Evaluation of proposed move for Water Right No. 33019

Proposed: Move water right no. 33019 to a new well location, 332 ft to the northeast.

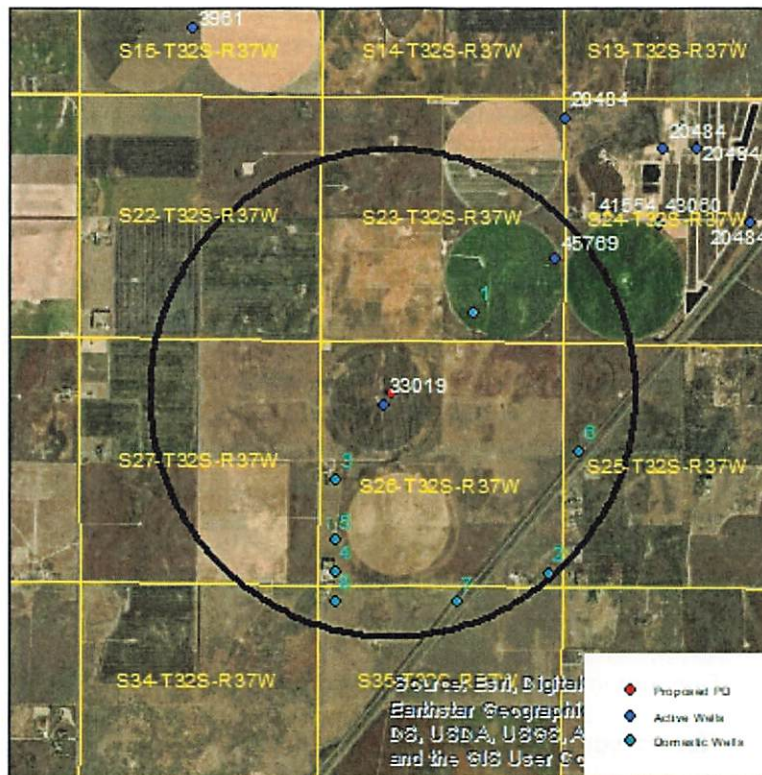
Wells within 1 mile: 45769 and eight domestic wells, numbered on the above map.

The saturated thickness at the proposed well location is estimated to be 407 ft, based upon the driller's log and an observation well in section 26-32-37. For saturated thickness greater than 400 ft, the drawdown allowance is 4.0 ft.

Net drawdown exceeds the drawdown allowance of 4.0 ft for all wells within 1 mile of the proposed location. Critical well analysis is necessary on those wells.
